RESPONSE TO REQUEST FOR ADDITIONAL INFORMATION

APR1400 Design Certification

Docket No. 52-046

RAI No.: 356-7881

Figure 7.7-14 I&C System Architecture for the RCC Panel

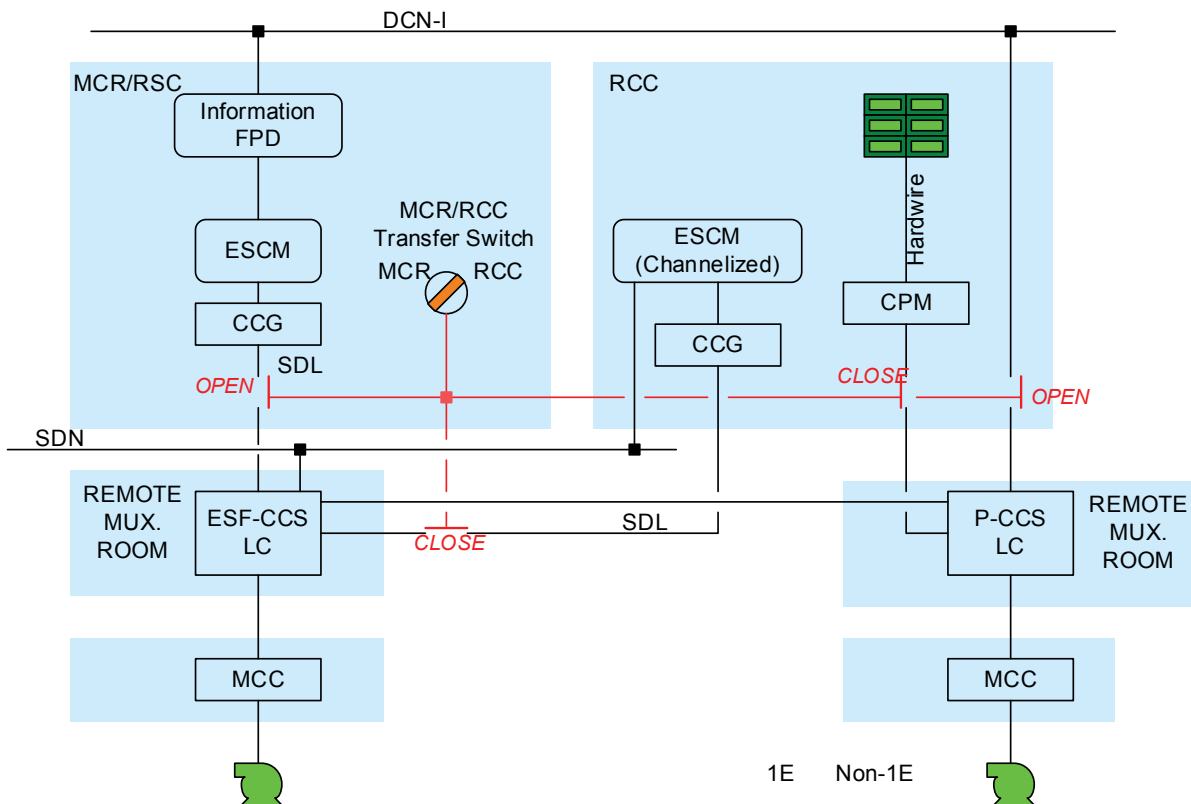
The applicant mentions that the RCC has safety and non-safety related controls available but does not state that RCC complies with any other applicable requirements for this configuration such as independence. The RCC is not depicted on Figure 7.1-1, "APR1400 I&C System Overview Architecture," therefore, there is no physical depiction of how the functionality of the RCC is taken into account within the overall I&C architecture or how its implemented. The acronym for the remote control center is also not defined in the acronym and abbreviation list in Section 7.0 of FSAR Tier 2. It cannot be determined what the difference is between the RCC and RSR.

1. Describe the RCC including all instrumentation, controls, and displays available at the RCC, all communications and architectural details used to implement the RCC, how the RCC addresses all the applicable requirements to the RCC (i.e. Independence), the specific design functions the RCC is intended to meet, the locations of RCC equipment (i.e. I&C cabinets, if applicable).
2. What is the difference between the RCC and the RSR?
3. Have the controls and displays available at the RCC been designed using the human factors engineering process as described in Chapter 18?

DCD Tier 2, Section 7.0 and Section 7.7.1.1 will be revised, and the depiction of the I&C architecture of the RCC will be added as Figure 7.7-14, as indicated in the attachment associated with this response.

The I&C system architecture for the RCC panel is shown in Figure 7.7-14
